Subject: Sikorsky Drawing Submittal in response to the USAF MH-53M Mishap Investigation

ENGINEERING ORDER

TRANSMISSION INSTL-
PYLON

NO 41242

VIEW E-E

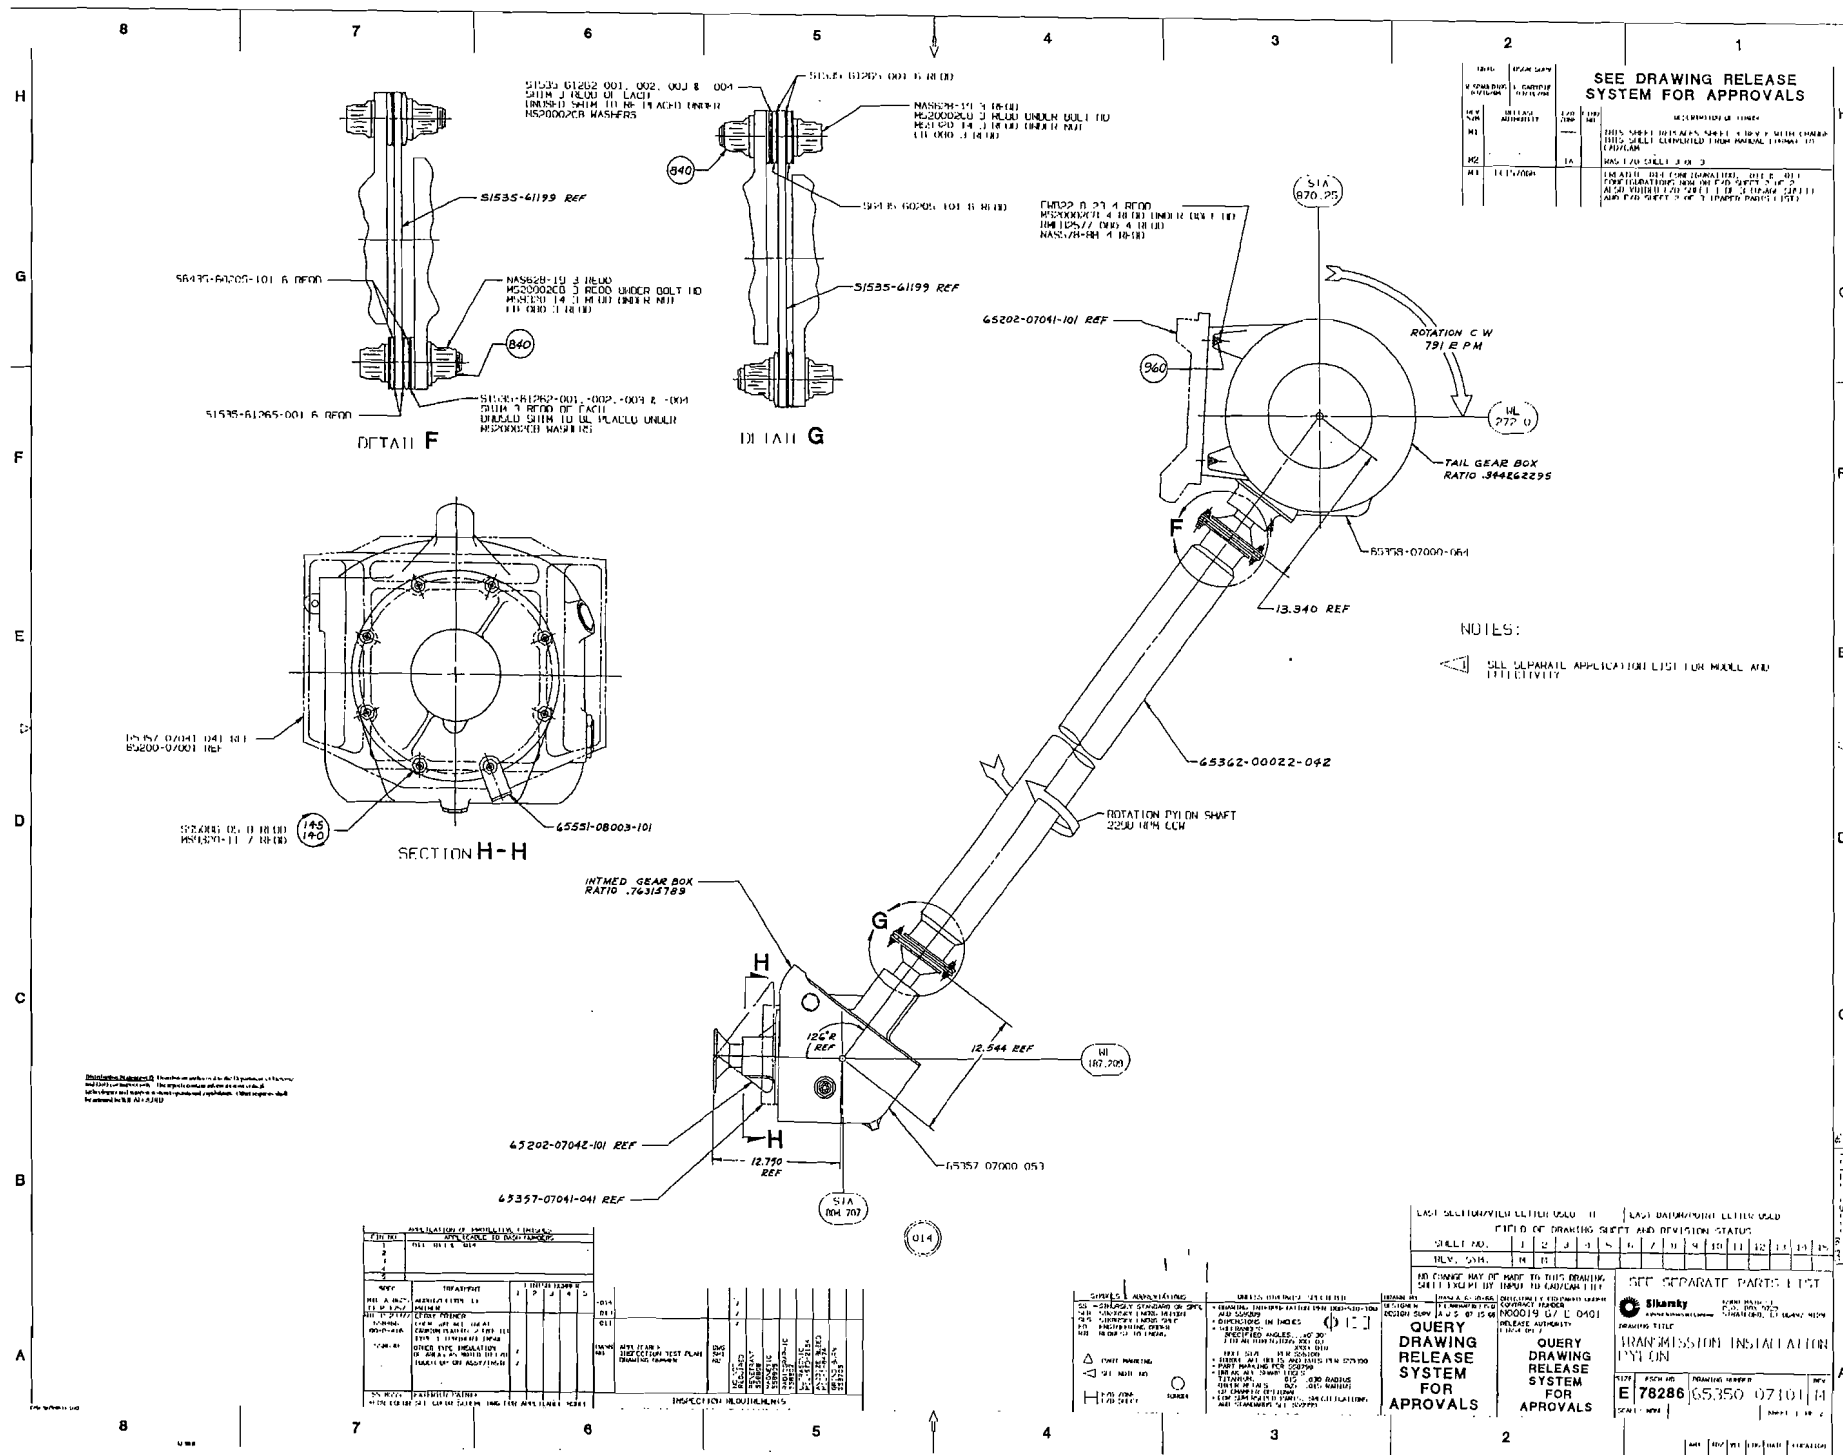
IN P/L SMT. #2, CHANGE AS SHOWN:

IN - 011 & - 013 COLUMN:

(WAS) MS21042-5 NUT 8 REQ'D
(NOW) SS5086-05 NUT 8 REQ'D

IN FLD SMT #3, CHANGE AS SHOWN:

(WAS) MS21042-5 (8 REQ.)

(NOW) SS5086-05 (8 REQ.)
